## SERVICE LETTER 00100

<b>Date Released:</b>	June 17, 2024
<b>Date Effective:</b>	June 17, 2024
<b>Subject:</b>	RV-14 Fuselage Laser-Cut Parts Remediation
<b>Affected Models:</b>	RV-14 fuselages constructed with a laser-cut F-01405A  RV-14A fuselages constructed with a laser-cut F-01405A, and/or F-01451-L/R, and/or F-01448A and/or F-01448C-L/R
<b>Required Action:</b>	Inspect the aforementioned parts for fatigue cracks propagated from fastener holes. In many places, cracks will not be visible until they have propagated beyond the flanges of overlapping parts. If cracks are present, replace the laser-cut parts with a punched part. If cracks are not present, install the alternate fix detailed below.
<b>Time of Compliance:</b>	Inspect within 200 flight hours or at the next annual inspection, whichever is earlier.  If fatigue cracking is not present, you may continue to comply with this Service Letter via ongoing inspection no less than every 12 months or 200 flight hours, whichever is first.  Upon or before reaching 1000 flight hours, the alternate fixes must be conducted as outlined in this Service Letter, at which point compliance has been met without need for ongoing inspection.

**FIGURE 12:** MODIFYING THE F-01481-L

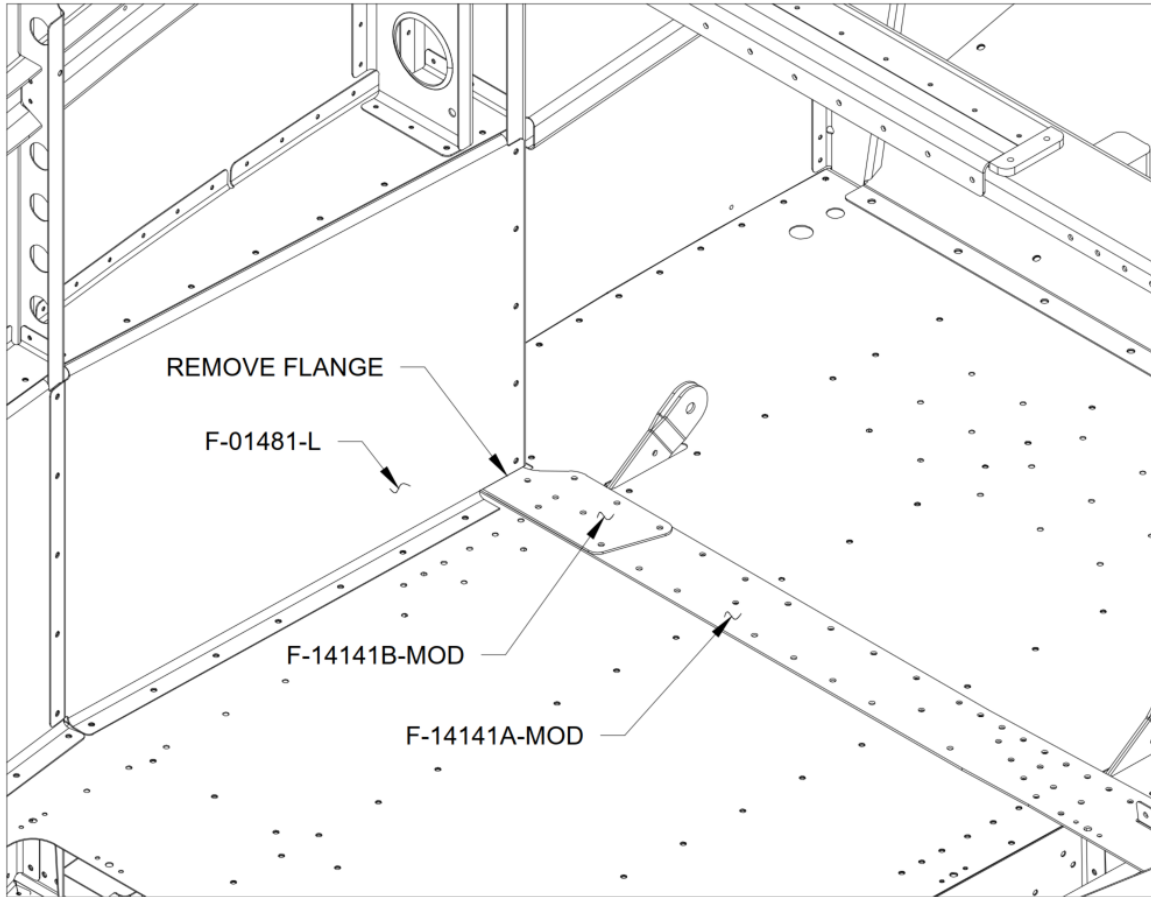
**Step 45:** Remove the foremost section of the bottom flange of the F-01481-L in order to clear the F-14141B-MOD and F-14141A-MOD as show in Figure 12.

**FIGURE 13:** FIREWALL ASSEMBLY AND TUNNEL SIDE  
(SHOWN WITHOUT OP-62 MODIFICATIONS)

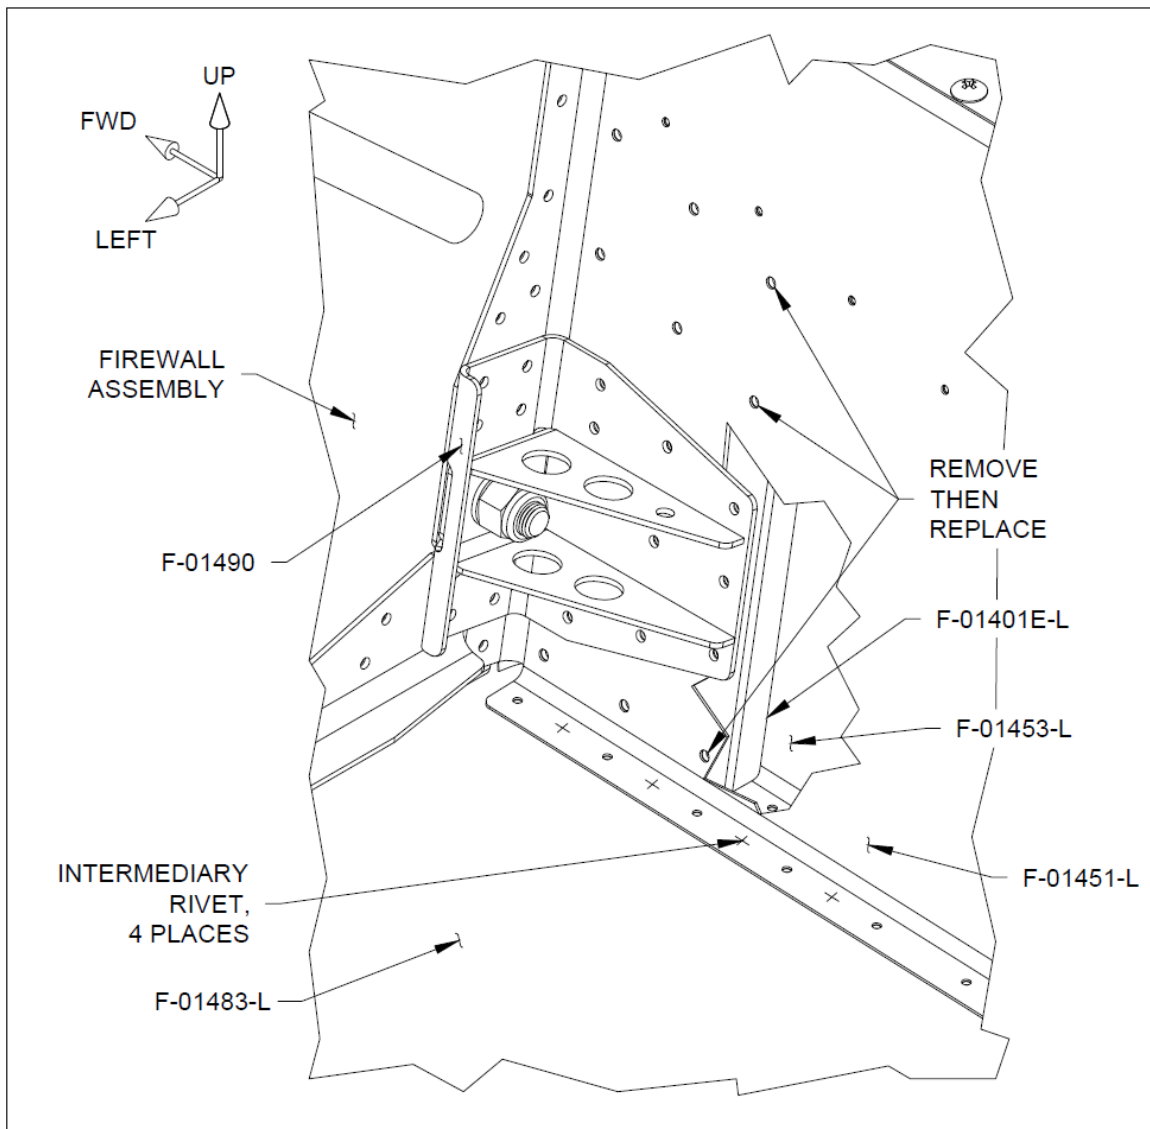
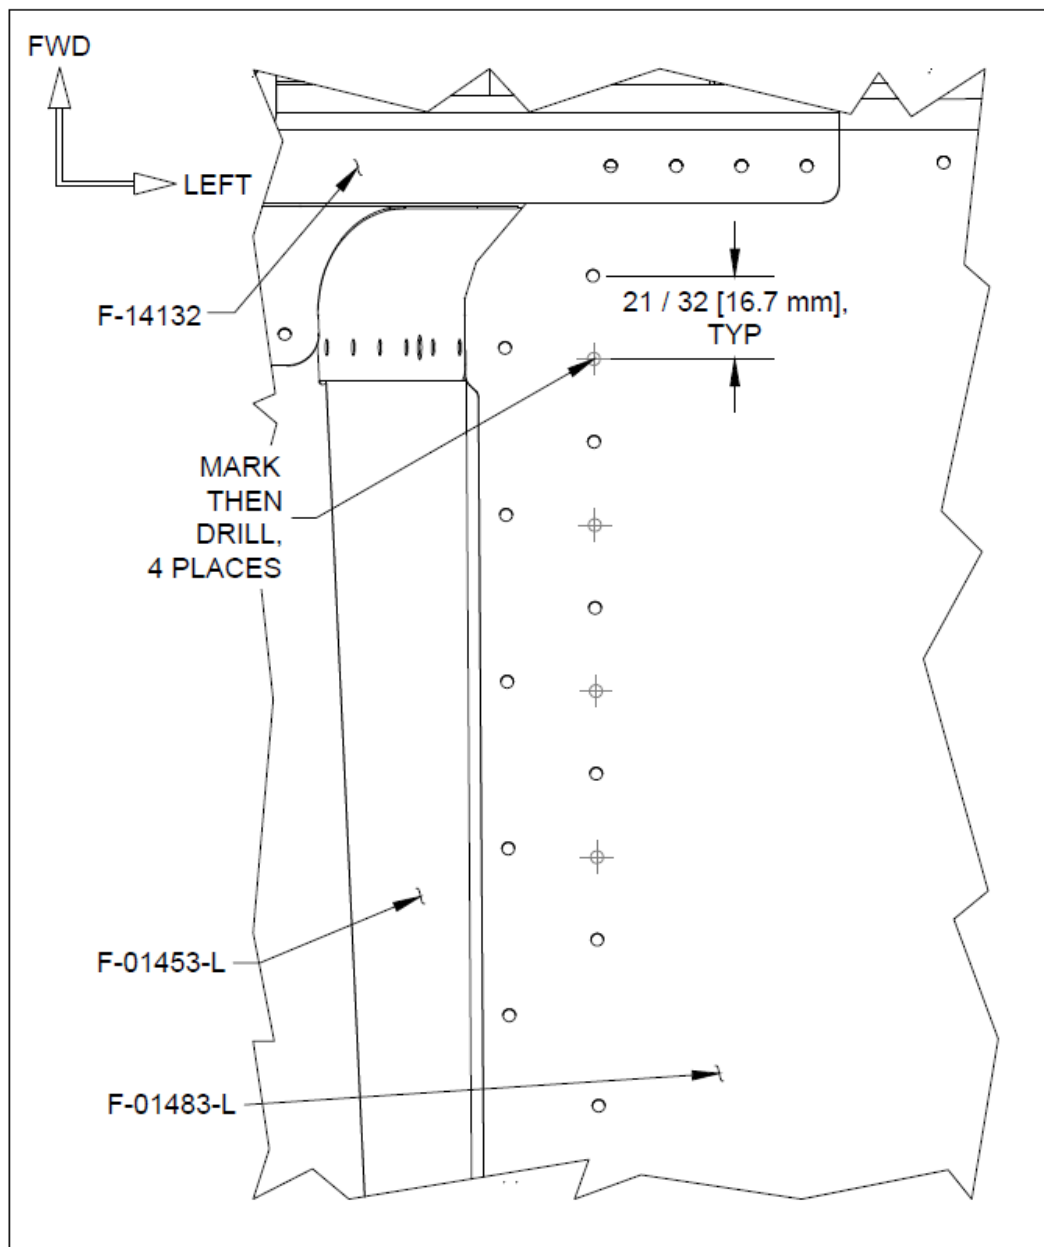
Step 53: Remove the three rivets called out in Figure 13 that join the F-01451-L Tunnel Side and the F-01401E-L Firewall Angle. A drill-stop is recommended to prevent damage due to the limited clearance between the tunnel side and underlying F-01453-L Muffler Shroud Side.

Step 55: Replace the removed rivets with CR3213-5-2 blind rivets. Reference Figure 13.

Step 56: From the bottom of the fuselage, mark the location of the four intermediary rivets to be added as shown in Figure 13 and 14.

Step 57: Drill #40 the locations just marked. Reference Figure 14.

Step 59: Install four AN426AD3-3.5 rivets into the holes just countersunk. Reference Figure 13 and 14.

**FIGURE 15: FIREWALL ASSEMBLY AND TUNNEL SIDE  
(SHOWN WITH OP-62 MODIFICATIONS)**

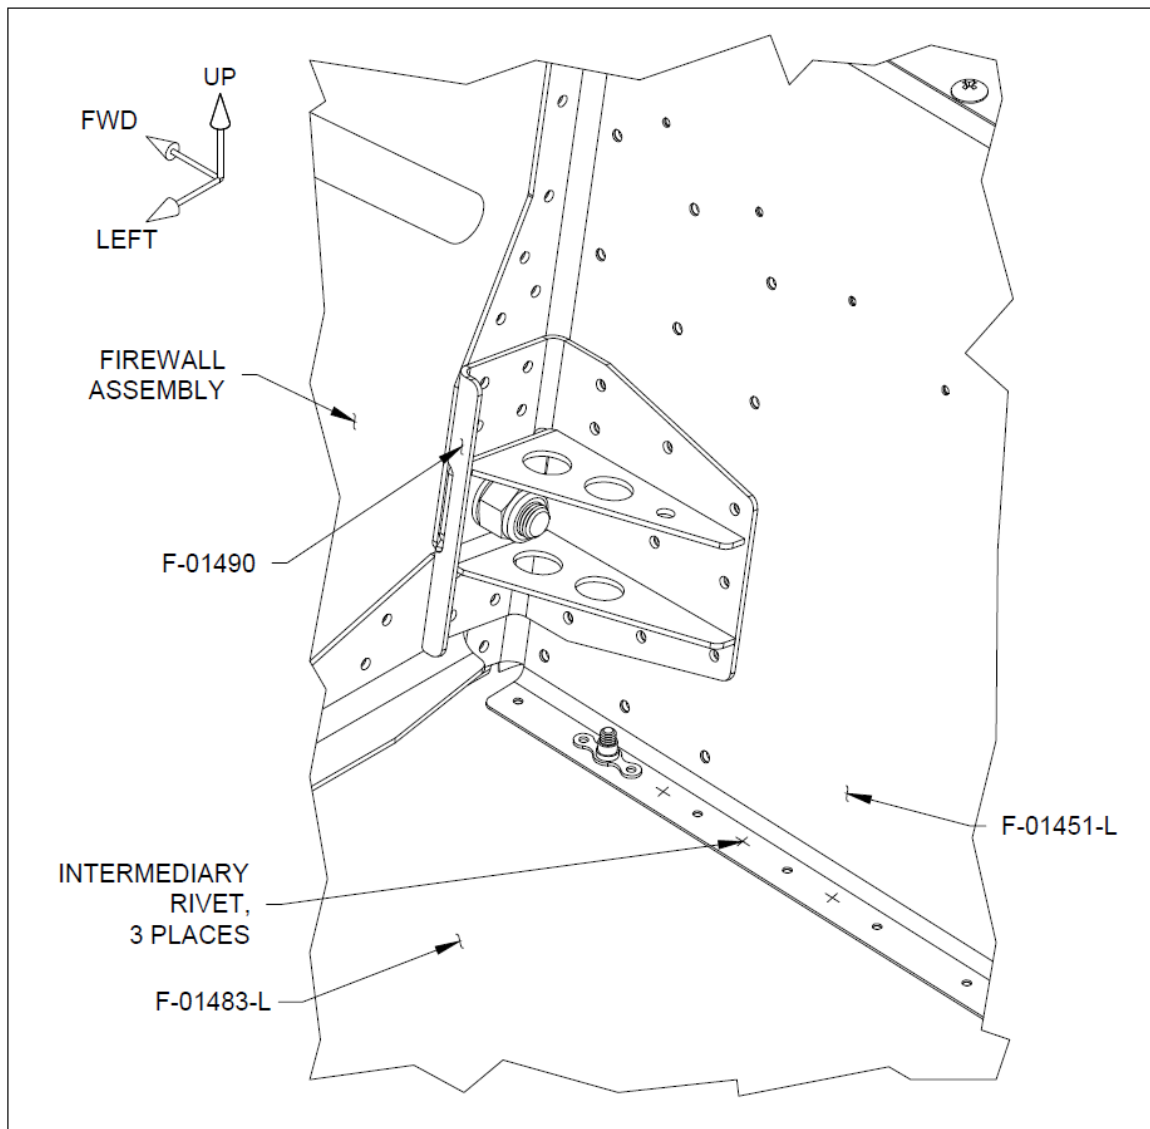
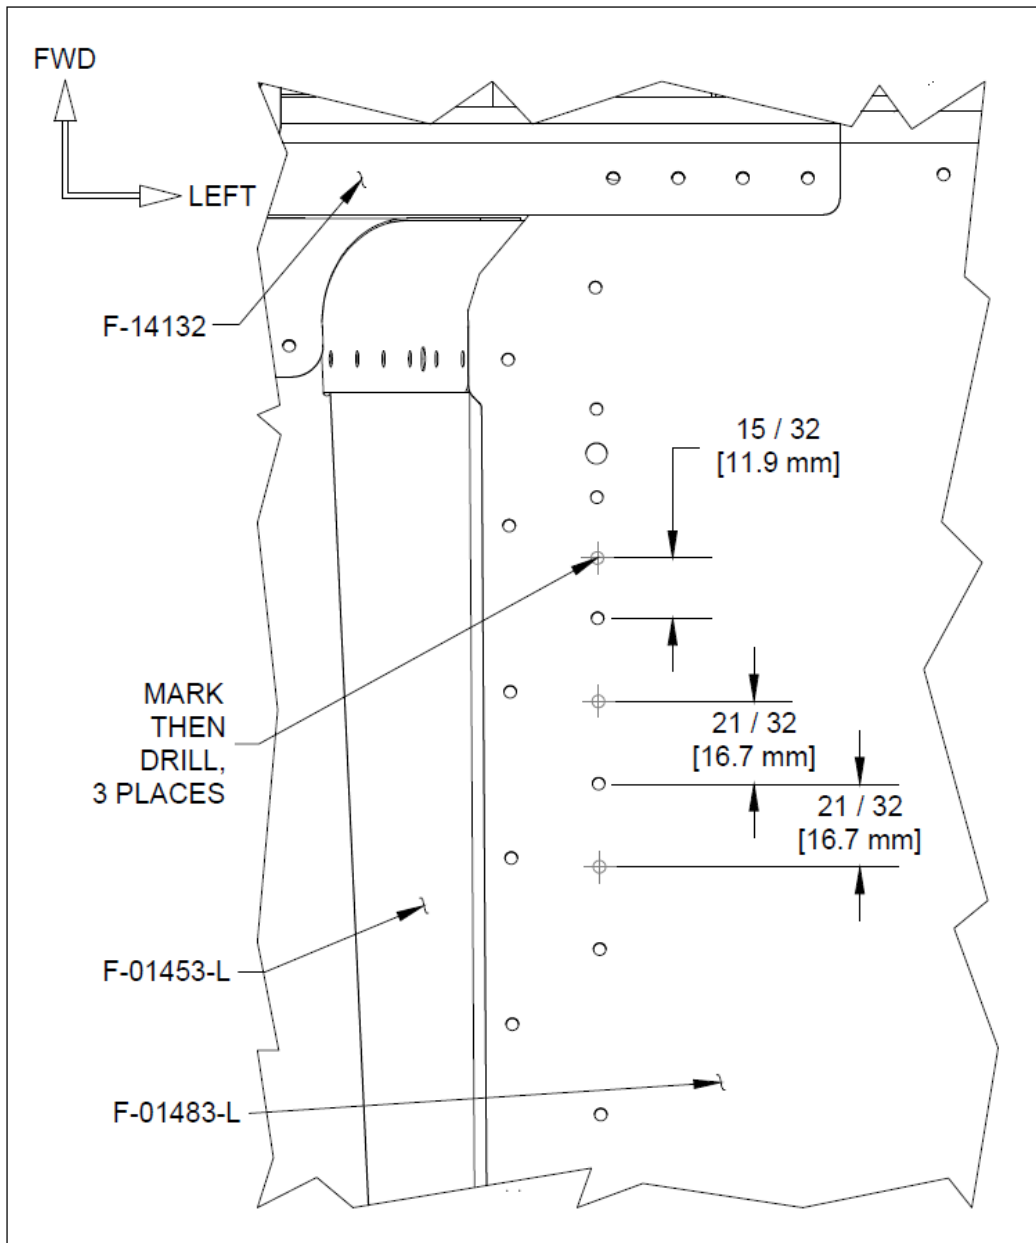
Step 60: From the bottom of the fuselage, mark the location of the three intermediary rivets to be added as shown in Figure 15 and 16.

Step 61: Drill #40 the locations just marked. Reference Figure 16.

Step 63: Install three AN426AD3-3.5 rivets into the holes just countersunk. Reference Figure 15 and 16.

**FIGURE 17:** REMOVING HARDWARE FROM AFT GEAR BRACE ASSEMBLY

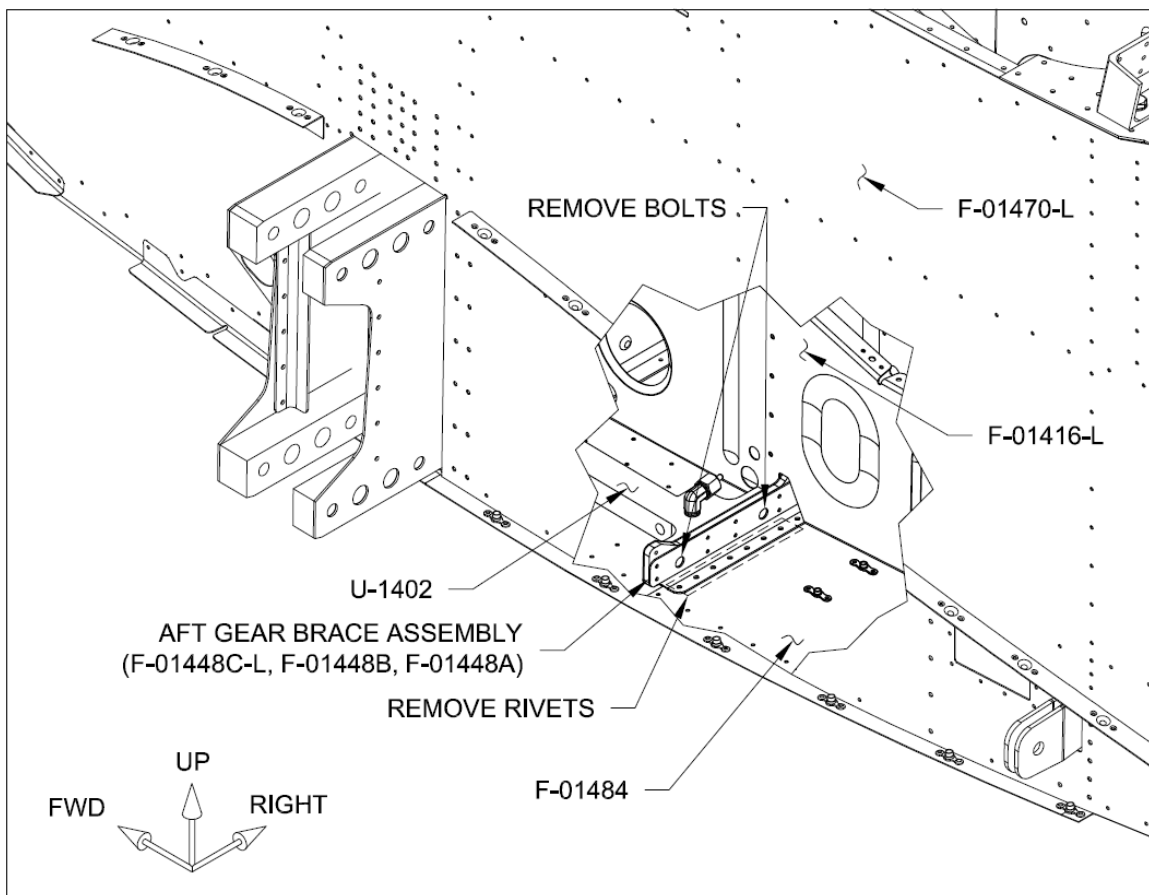
Step 68: Remove the two bolts securing the U-01402 to the Aft Gear Brace Assembly, as called out in Figure 17.

Step 69: Remove the seven outboard rivets attaching the Aft Gear Brace Assembly to the F-01484 Center Bottom Skin, as called out in Figure 17.

**FIGURE 18:** MATCH-DRILLING FOR F-01448D-L AND F-01448E.

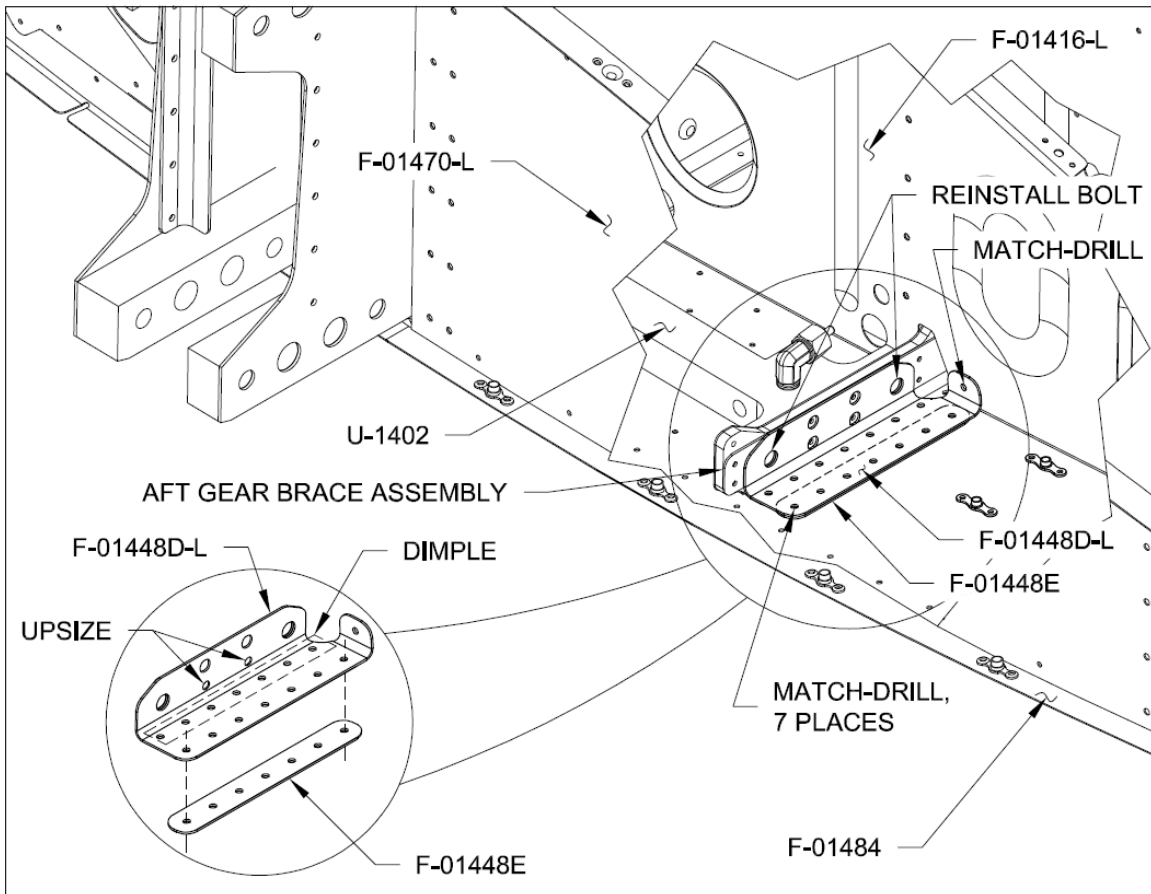
Step 70: Dimple the seven holes in the F-01448D-L Gear Brace Clip as called out in the detail view of Figure 18.

Step 71: Use a step drill to upsize the two .188 [4.8mm] holes in the F-01448D-L Gear Brace Clip as called out in the detail view of Figure 18.

Step 72: Position the F-01448D-L and F-01448E Gear Brace Spacer into the fuselage as shown in Figure 18.

Temporarily reinstall the two bolts through the U-01402 and Aft Gear Brace Assembly, clamping the F-01448D-L. See Figure 18.

Step 73: Match-Drill #30 and cleco the seven holes from the F-01448D-L and F-01448E into the F-01484 as called out in Figure 18.

Step 74: Match-Drill #30 the single hole from the end-flange of the F-01448D-L into the F-01416-L Seat Rib. See Figure 18.

**FIGURE 19:** INSTALLING F-01448D-L AND F-01448E.

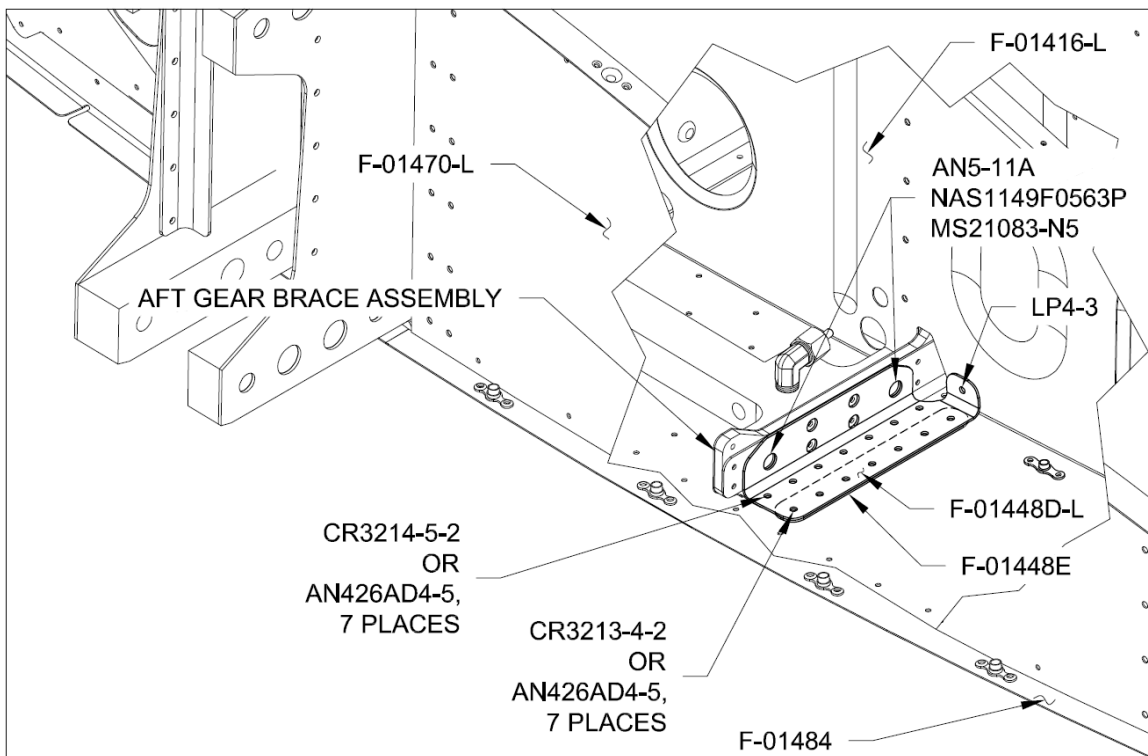
**NOTE:** Universal head or flush head rivets can be used on the belly to rivet the aft row of the F-01448D-L to the underlying structure as called out in Figure 19. If installing universal head rivets, skip to Step 78.

Step 78: Rivet the F-01448D-L and F-01448E to the underlying structure as called out in Figure 19.

Step 79: Install the bolts through the Aft Gear Brace Assembly as called out in Figure 19.
